**Sent:** 27/10/2022 5:06:50 PM  
**Subject:** DA2022/1675 - Lot 30 DP 25654 57 Cutler Road, Clontarf - Objections to Proposed Development  
**Attachments:** Sydney Water Sewerage Service Diagram 3 Castle Rock Crescent, Clontarf.pdf;

Dear Ms Surtees, in reference to the DA 2022/1675 Lot 30 DP 25654 - 57 Cutler Road, Clontarf please see below our objections to this proposed development.

## SEWERAGE SERVICE DIAGRAM

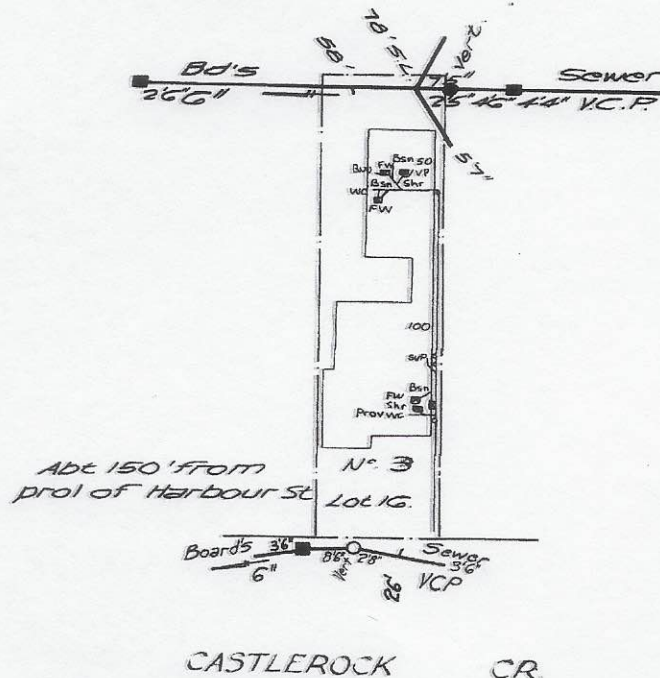
3. We do not accept the exception for reduction of the outer edge of the pool be reduced and are very concerned regarding excavation required for a swimming pool considering there is a sewer line that sits very close to our rear boundary (diagram attached). We are most concerned as to potential impact of drilling into the sandstone so close to this ageing pipeline.
